The Dow Chemical Company
Midland, Michigan 48667

Enclosed is the response to your request for additional information regarding our amendment request for Facility Operating License R-108; letter dated April 17, 1997. The enclosure includes the changes proposed for amendment No. 7 and an explanation for the question raised in your letter. If you have any questions regarding this review, please contact me at (517) 636-6584.

Ward L. Rigot
Reactor Supervisor
Dow TRIGA Research Reactor
The Dow Chemical Company

Figure 6.1. Administration

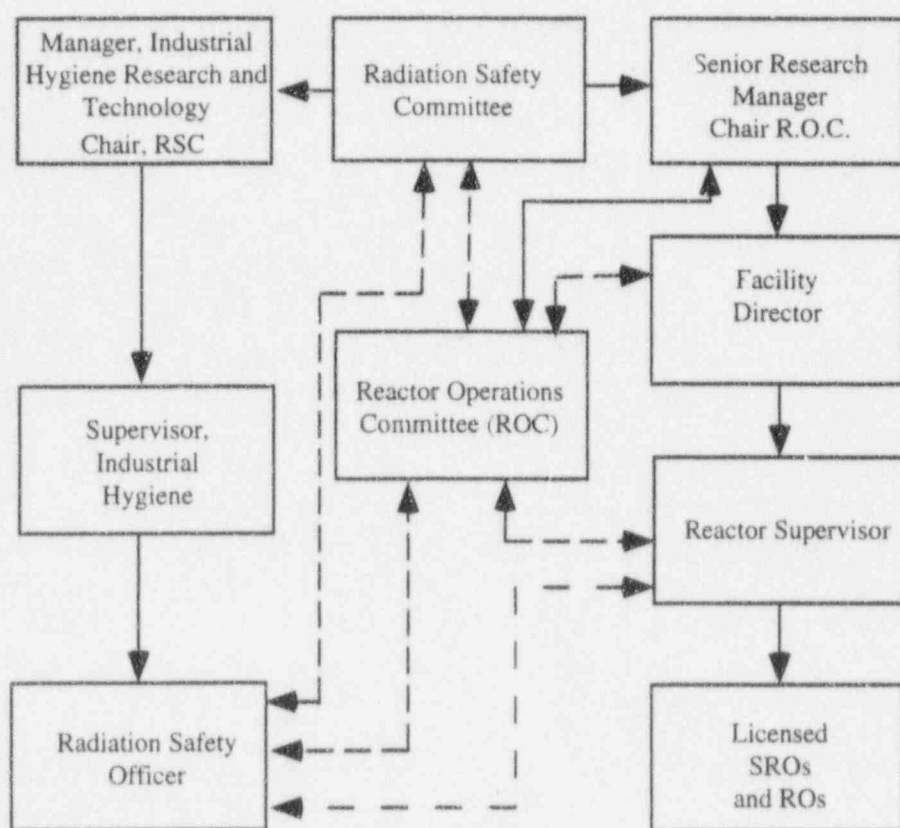
1. Figure 6.1 has been modified to show the separation of the operations and safety arms of the reactor's administration. The license is held by the radiation safety committee (RSC) which is chaired by The manager of Industrial Hygiene Research and Technology. This person serves as a Level 1 manager as described in ANSI/ANS 15.1-1990. In addition, Operations report to a Senior Research Manager within Analytical Sciences Laboratories. The Radiation Safety Committee is responsible for all aspects of radiation safety including issues related to the TRIGA reactor. For issues related to radiation safety the operations arm of the organization reports through the Senior Research Manager within Analytical Sciences Laboratories to the Radiation Safety Committee. The person responsible for reactor facility operations is the Facility Director and the person responsible for day-to-day operation of the reactor is the reactor supervisor. The role of Facility Director and Reactor Supervisor may be filled by the same person.

2. The Reactor Operations Committee reports to The Senior Research Manager within Analytical Sciences Laboratory. Members of the committee not required by the Technical Specifications (i.e. Radiation Safety Officer and Reactor Supervisor) are appointed by This Level 1 manager.

3. The Radiation Safety Officer communicates with the Level 3 management (Reactor Supervisor) and this reporting line has been added. The radiation safety function reports through The Manager, Industrial Hygiene Research and Technology, a level 1 manager.
